RENESAS TECHNICAL UPDATE

Product Category	MPU/MCU		Document No.	TN-RL*-A040A/E	Rev.	1.00
Title	Correction for Incorrect Description Notice RL78/G13 Descriptions in the Hardware User's Manual Rev. 3.20 Changed		Information Category	Technical Notification		
Applicable Product	RL78/G13 R5F100xxx, R5F101xxx	Lot No.	Reference Document	RL78/G13 User's Manual: Hardware Rev.3.20 R01UH0146EJ0320 (July. 2014)		
		All lots

This document describes misstatements found in the RL78/G13 User's Manual: Hardware Rev.3.20 (R01UH0146EJ0320).

Correction for incorrect position of index mark of 25-pin product in bottom side. (p.19)

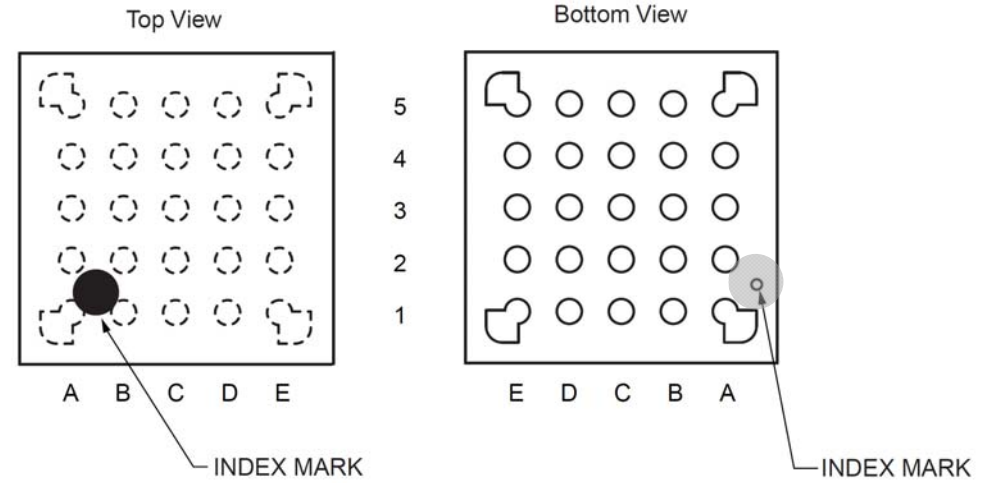
1. Position of Index mark of 25-pin product. (Page 19 and 1053)
